MEMORANDUM

From:	Built Heritage Officer		
Service	Green Infrastructure	App No:	250983
Address:	5 Remenham Terrace, White Hill, Remenham Hill, Wokingham, RG9 3EN		
Proposal:	Application for submission of details to comply with the following condition of planning consent 242351 dated 06.11.2024. Condition 5 relates to full working details of windows and external doors and related joinery.		
Heritage Asset:	Remenham Hill Terrace – Grade II listed building Setting of Park Place and Temple Combe – Grade II* Registered Park and Garden Listed building along with conservation areas are classed as designated heritage assets under the NPPF (2024) and in the Council's Local Plan policies.		
Site Visit Made:	Yes, external only

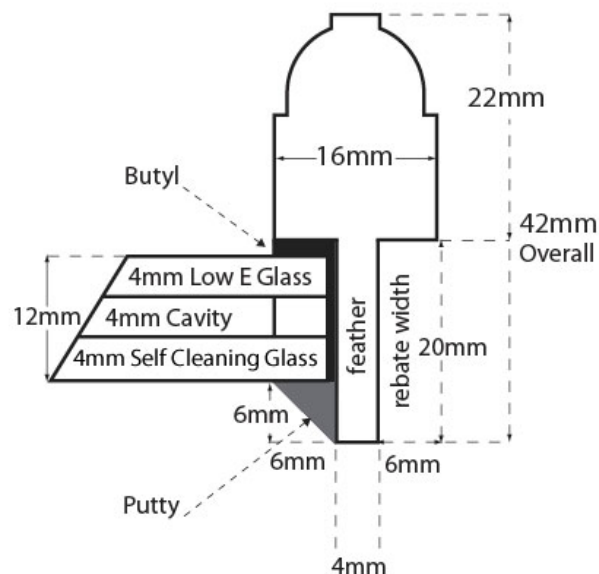
- It would be expected for further details to be provided as part of the discharge of condition application, with the related drawings – referred to as ‘Sash windows A&B elevations.pdf’ and ‘Sash windows A&B sections scale 1-5 A4.pdf’ not appearing to be correctly detailed or scaled, nor appropriately annotated and referenced to the approved drawings. It would also be expected details of the glazing bars, such as the following example, be provided:
